*Bridge Preliminary Design Report
Addendum*

**Ramp C over Fairground Road
SCI-823-1595**

**SCI-823-10.13
PID No. 79977**

Prepared for
Ohio Department of Transportation

Site Plan - Sheet 1 of 3

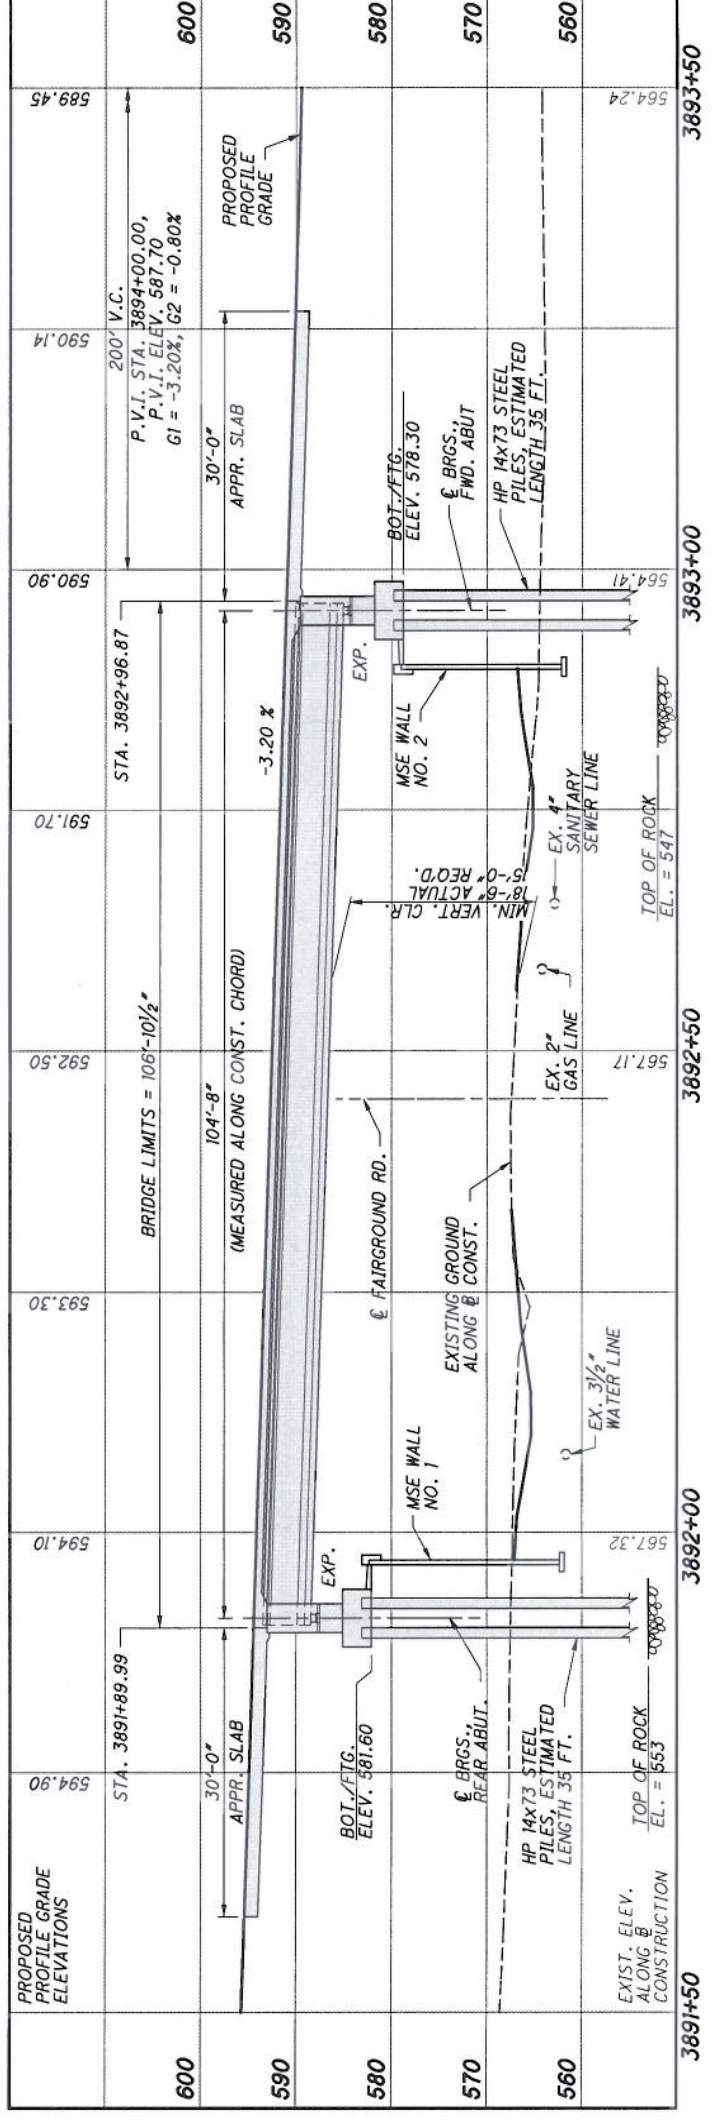
4. Please check if the 45-degree turnback wingwall can be utilized at the Northwest and Northeast wingwalls similar to what is being proposed at the Southwest and Southeast wingwalls.
5. The actual unfactored design load of 95 tons corresponds to HP12x53 instead of HP 14x73 piles. Please refer to BDM 202.2.3.2.a which was updated in the 2007 Fourth Quarter Revisions. The increase in the maximum allowable design loads for H-piles driven to refusal is to take advantage of the Grade 50 steel that is now used for steel piles.
6. Please provide the location and description of benchmarks in the next submittal. (BDM 202.2.1)
7. In the Proposed Structure data block, Length of Span on curved alignments should be measured along a reference line which a chord drawn from centerline of abutment bearings at the centerline of survey or baseline construction. (BDM 202.2.1)

4	Please check if the 45-degree turnback wingwall can be utilized at the Northwest and Northeast wingwalls similar to what is being proposed at the Southwest and Southeast wingwalls.	The northeast and northwest wingwalls are turned back at a ±45-degree angle. The wingwalls at the southeast and southwest corners cannot be bent back at a 45-degree angle. These wingwalls butt up against the wingwalls from SCI-823-1594 (SR 823 over Fairground Rd) to form a continuous retaining wall. This wall retains soil so that this area can drain away from the MSE walls. We do not propose to change the layout of the southeast or southwest wingwalls.

5	The actual unfactored design load of 95 tons corresponds to HP12x53 instead of HP 14x73 piles. Please refer to BDM 202.2.3.2.a which was updated in the 2007 Fourth Quarter Revisions. The increase in the maximum allowable design loads for H-piles driven to refusal is to take advantage of the Grade 50 steel that is now used for steel piles.	Acknowledged.
6	Please provide the location and description of benchmarks in the next submittal. (BDM 202.2.1)	Benchmark information will be provided as soon as that information is available.
7	In the Proposed Structure data block, Length of Span on curved alignments should be measured along a reference line which a chord drawn from centerline of abutment bearings at the centerline of survey or baseline construction. (BDM 202.2.1)	Acknowledged. Span length will be measured along the baseline which is a chord drawn from the Centerline Rear Abutment Bearing to Centerline Forward Abutment Bearing.

TYPICAL TRANSVERSE SECTION

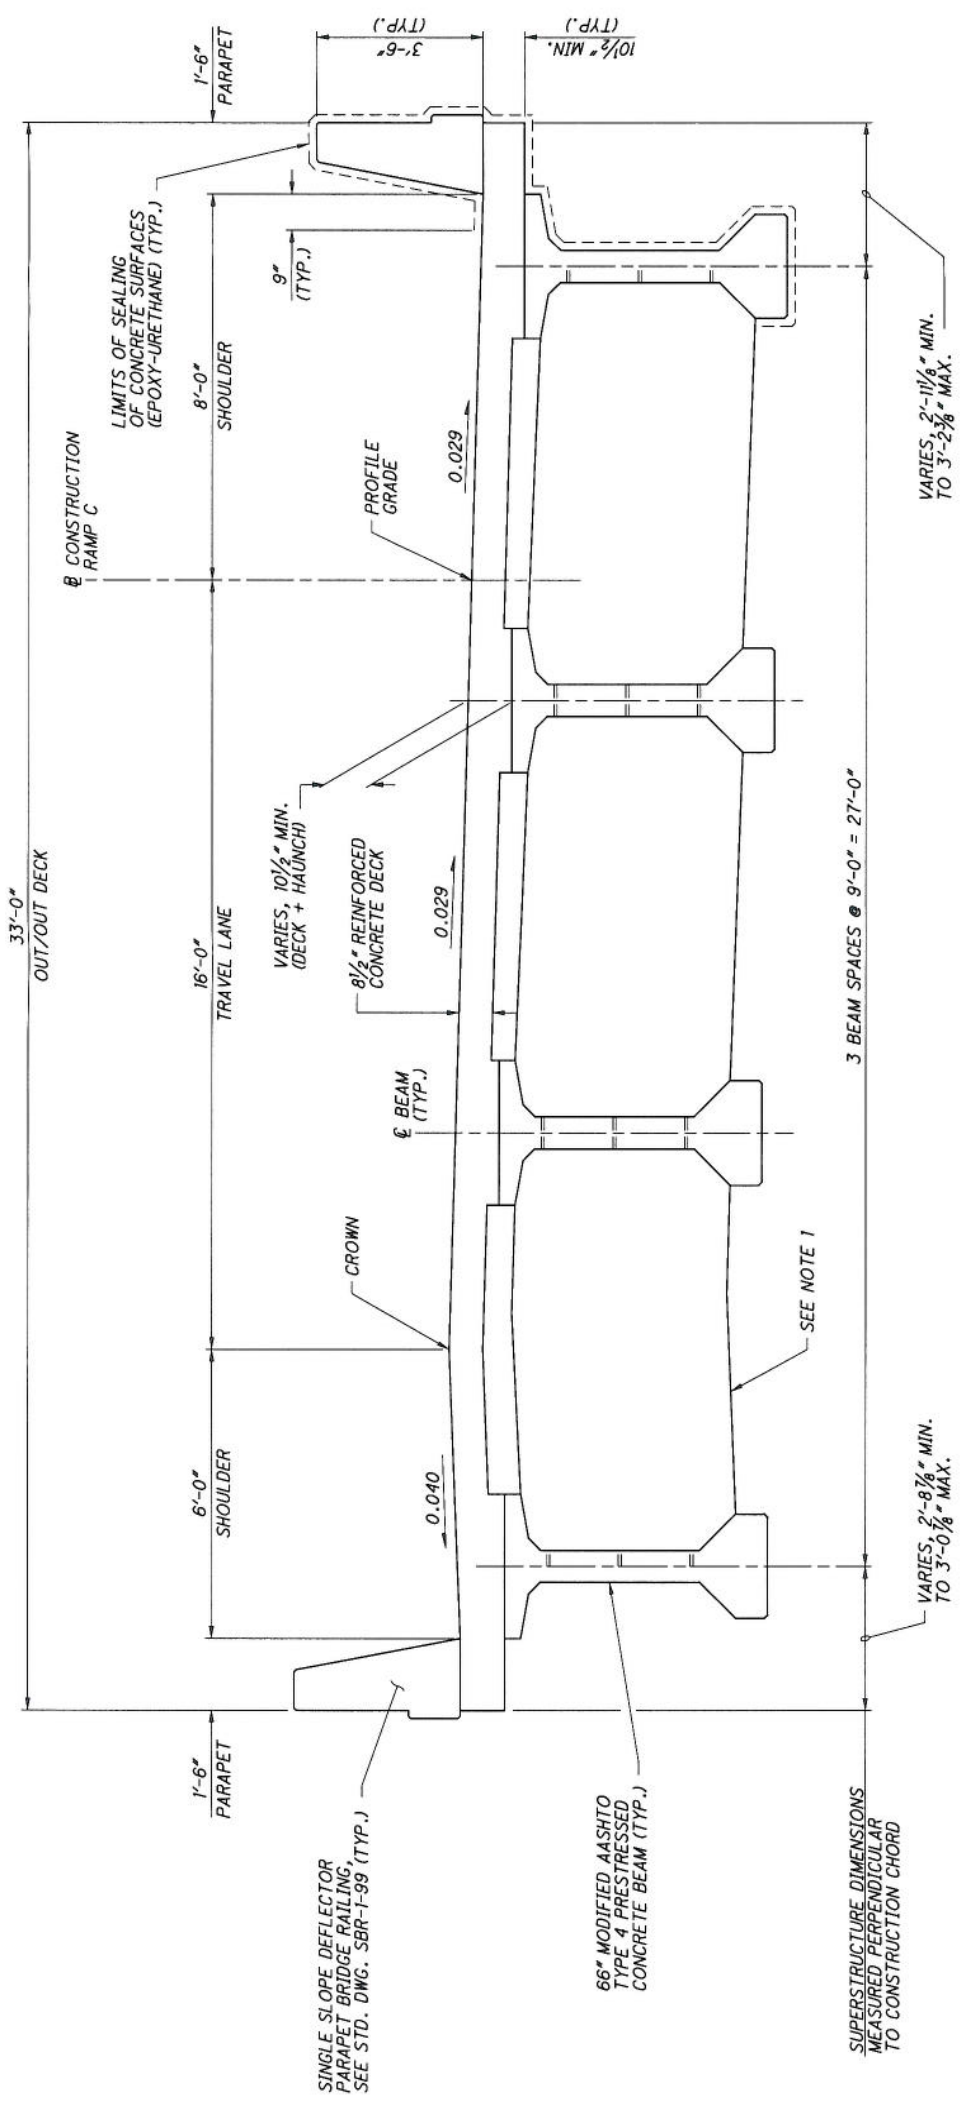
1. We agree that the proposed structure should consist of single span composite prestressed concrete I-beams with reinforced concrete deck and semi-integral abutments supported on MSE walls. However, the number of proposed prestressed concrete I-beams has been increased by one beam. In the Structure Type Study submitted in March 2007, the Design Consultant proposed four (4) AASHTO Type 4 prestressed concrete I-beams spaced at 9'-0" c/c. In this Preliminary Design submission, five (5) Modified AASHTO Type 4 (60") prestressed concrete I-beams are being proposed. Since vertical clearance is not going to be an issue at this particular location, we would like to know if the Design Consultant investigated and also performed cost comparisons for using four (4) Modified AASHTO Type 4 (66" or 72") prestressed concrete I-beams spaced at 9'-0" c/c. We request the Design Consultant to provide us with additional information prior to proceeding with Detail Design. Review comments pertaining to the MSE wall will be submitted separately. Please incorporate MSE wall comments prior to proceeding with Detail Design.

Comment No.	Review Comment	Designer Response
	Preliminary Design Review: SCI-823-1595 Ramp C over Fairground Road	
1	<p>We agree that the proposed structure should consist of single span composite prestressed concrete I-beams with reinforced concrete deck and semi-integral abutments supported on MSE walls. However, the number of proposed prestressed concrete I-beams has been increased by one beam. In the Structure Type Study submitted in March 2007, the Design Consultant proposed four (4) AASHTO Type 4 prestressed concrete I-beams spaced at 9'-0" c/c. In this Preliminary Design submission, five (5) Modified AASHTO Type 4 (60") prestressed concrete I-beams are being proposed. Since vertical clearance is not going to be an issue at this particular location, we would like to know if the Design Consultant investigated and also performed cost comparisons for using four (4) Modified AASHTO Type 4 (66" or 72") prestressed concrete I-beams spaced at 9'-0" c/c. We request the Design Consultant to provide us with additional information prior to proceeding with Detail Design. Review comments pertaining to the MSE wall will be submitted separately. Please incorporate MSE wall comments prior to proceeding with Detail Design.</p>	<p>Beam study has been completed. Four AASHTO Modified AASHTO Type 4 (66") Beams at 9'-0" centers are adequate. However, the preliminary analysis indicates that a concrete strength of 5,500 psi at release is required. This exceeds ODOT's recommended maximum of 5,000 psi. We have coordinated with suppliers through PCI and they have indicated that a 5,500 psi requirement is not a problem. It is recommended that four AASHTO Modified AASHTO Type 4 (66") Beams at 9'-0" centers be used for this bridge.</p>
